Site Inspection Form

Dam Name: Oyster River Dam **Dam No.:#** 71.03 **Town:** Durham
Date Inspected: 09/18/07 **Owner:** Durham Public Works

Oyster River Mill Dam #71.03 Durham, NH

Elevation View Upstream

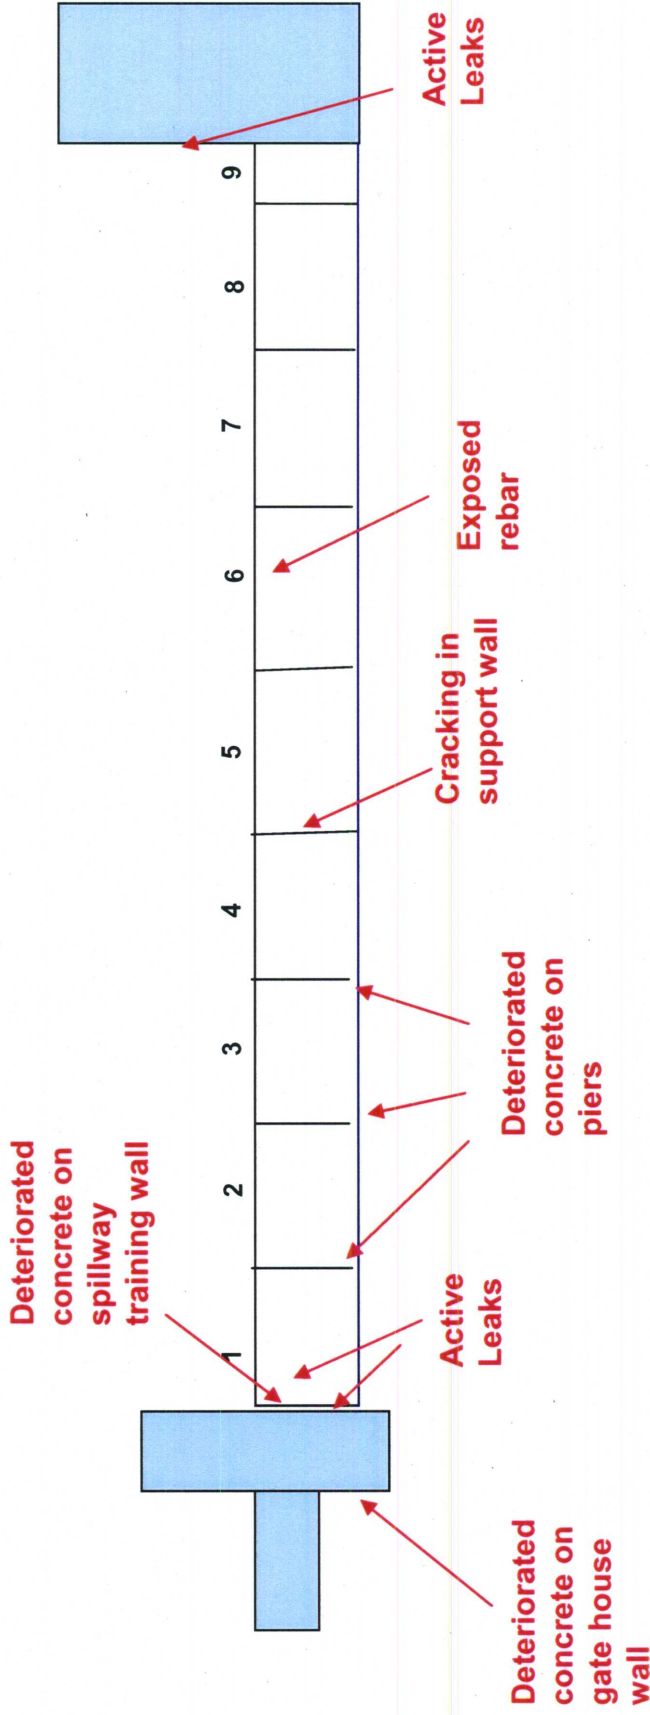
- On the gate house structure/spillway training wall. An eroded section of the right concrete spillway training wall measured 6" deep.
 - The upper and lower portions of the eight concrete piers supporting the spillway slab. Along the base of the left abutment wall of the gate structure/right spillway training wall. Rebar was also exposed in this area.

- To the right of the low level gate at the base of the downstream face.
 - On the interior ceiling of bay 6 (counting from right end). Rebar was also exposed.

Failed mill foundation - stone was added to stabilize area

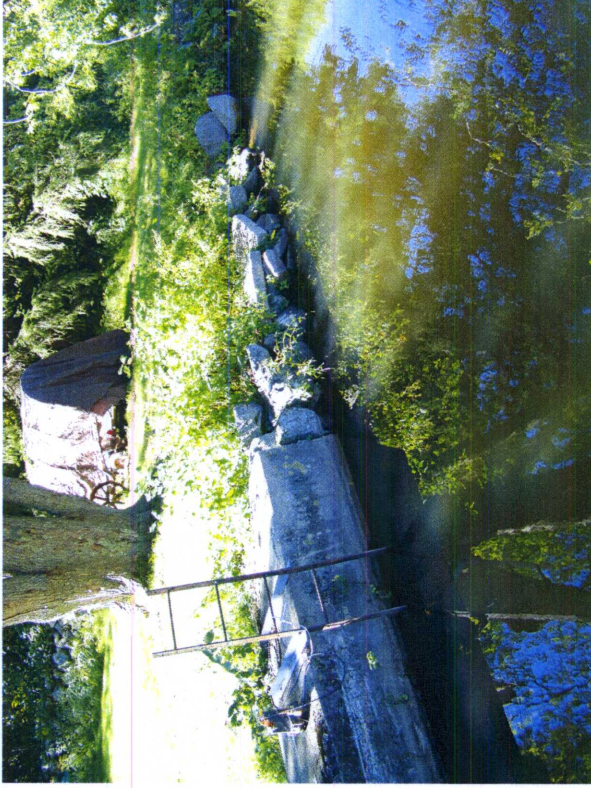
- 1) There was damage to the right abutment from the past two flood events. Soil had settled and eroded from the right earthen embankment adjacent to the concrete/stone training wall. The old mill foundation had suffered extensive damage from the floods. Some repairs have been made by the property owner on the right bank.

Area that overtopped during 4/16/07 flood event

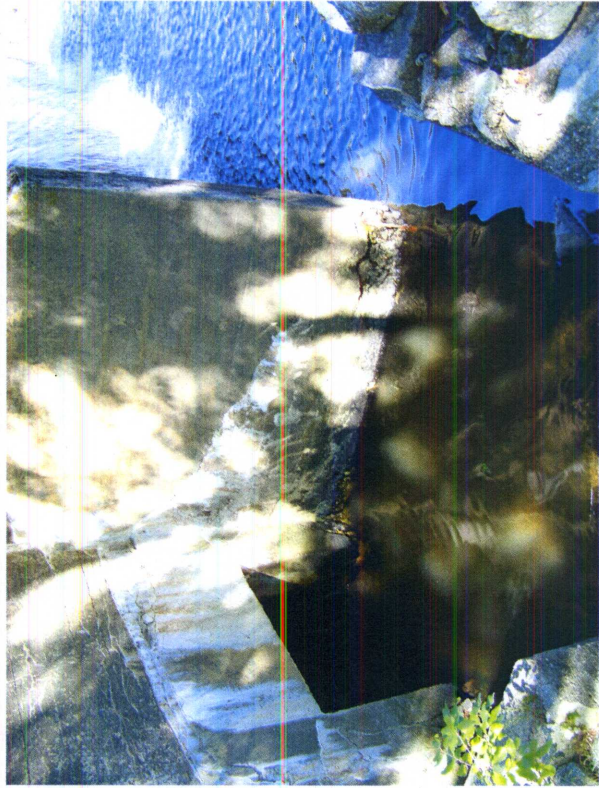
Deteriorated concrete at base of pier serving as left gate housing

Some settlement of left embankment near fishway

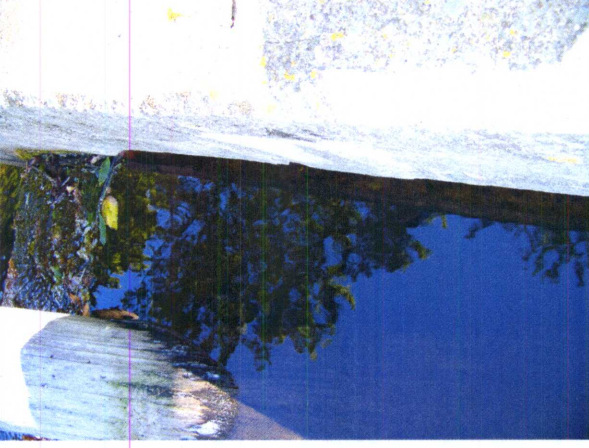
Leak in left spillway training wall at fishway

Right spillway training wall - 6" deep deterioration on wall at water

Bay 6 - efflorescence

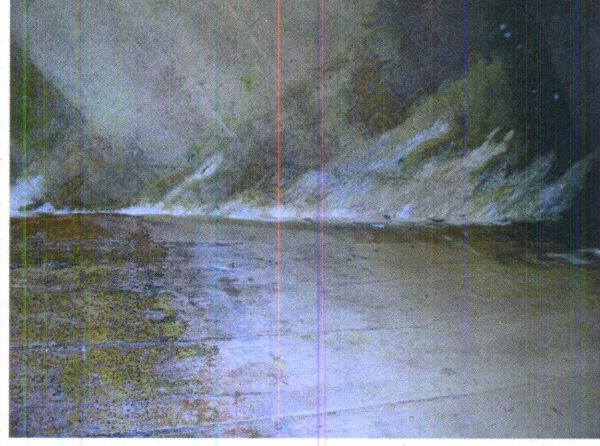
Bay 6 - exposed rebar on ceiling

bay 5 - Cracking in Bay 5/4 support wall

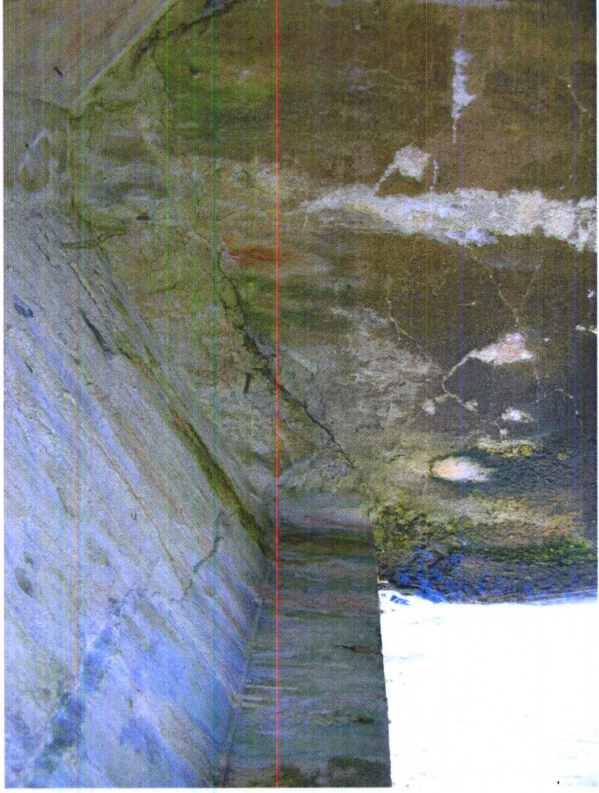
- There was concrete cracking in the support wall of Bay 4 & 5 (Refer to attached photo).
- 4) There was active leakage noted in Bay 1 along the ceiling at the spillway slab and spillway training wall junction. Leakage was also noted at the upstream toe of the right spillway training wall inside Bay 1 (refer to photos).

Bay 5 - Crack in Bay 5/4 support wall

Bay 1 - active leak on connecting gate house wall

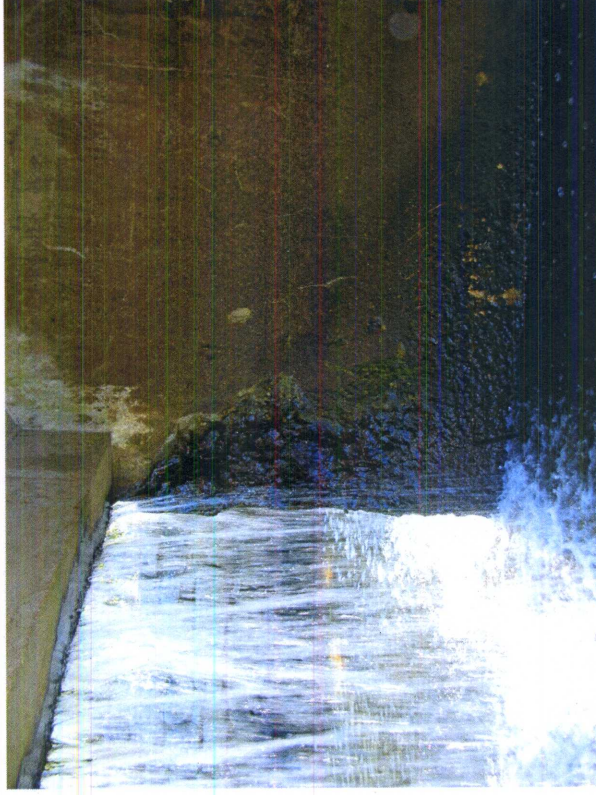
Bay 1 - active leakage from spillway slab adjacent to gate chamber
